Claim 1 has been amended, with the details set forth in Attachment I (Version with Markings to Show Changes Made).

Attachment I
S.N. 09/538,354
Version with Markings to Show Changes Made

FIG. 2A

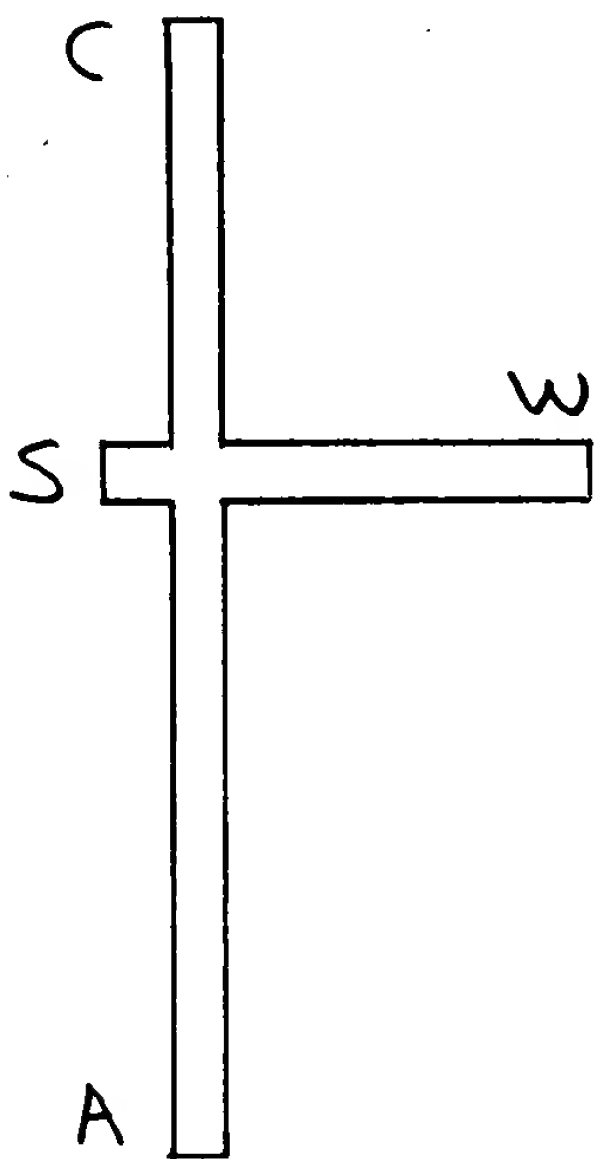
While the Office Action indicates that the drawings as filed on March 29, 2000 are accepted, the drawing do not accurately reflect the description as set forth in the specification. Thus, proposed drawing changes are submitted for approval of Figures 2A, 2B, 2C and Figure 3, with the proposed changes shown in red ink on the enclosed photocopies. Upon approval, the drawing changes will be incorporated into formal drawings to be submitted upon allowance of the claims.
